Precinct resolution

PRECINCT: Kingsford East Precinct EMAIL: kingsfordeastprecinct@gmail.com

MEETING 02 April 2025 FILE: F2024/00015

RESOLUTION Resolution 02042025(2)

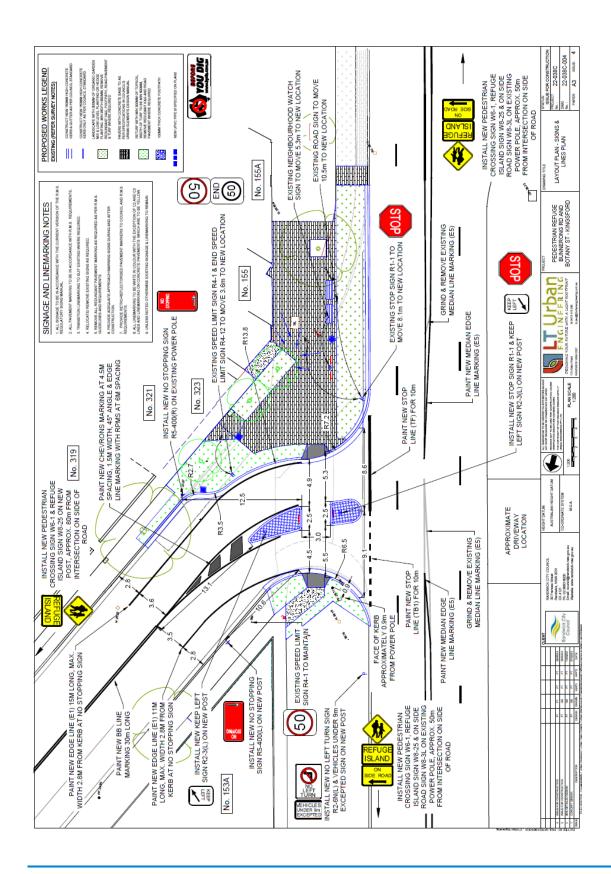
The Botany St and Bunnerong Rd intersection is dangerous. It is very wide and cars enter Botany Street from Bunnerong Road at high speed. And there are significant volumes of pedestrian traffic on this section of road. There are also issues with the flow of traffic in this general vicinity.

Resolution 02042025(2): The Precinct requests that Council improve the safety of the Bunnerong and Botany Street intersection by improving pedestrian safety (such measures could for example include a median island, pedestrian refuge and kerb blisters) similar to the treatment on the corner of Bunnerong Rd and Birdwood Avenue. Such measures could also improve traffic flow.

Thank you for the Precinct's suggestion. As it happens, I too have had significant concerns about this wide "bell-mouthed" intersection for some time. In particular, I had concerns about the 27 metre wide exposure of pedestrians to moving vehicles. Because Botany Street meets Bunnerong Road at a shallow 45° angle, pedestrians walking along the eastern path of Bunnerong Road have had a very long crossing distance. I also have had strong concerns that northbound Bunnerong Road motorists treat right turns into Botany Street like a "shallow angled freeway off-ramp". The shallow angle means rat-running through traffic motorists can exit Bunnerong Road at speed.

Given the above concerns, I arranged for a redesign of the intersection, and I managed approvals and local consultation through the Traffic Committee processes in 2023. Once implemented, pedestrians' exposure to moving vehicles will be reduced from 27 metres down to only 10.8 metres. And right-turning motorists will have to turn more slowly, through a 90° bend, to enter Botany Street.

I can report that funding is now available for this project and that construction is due within the next two months. For the information of the Precinct I have attached, on the following page, a copy of the final design.
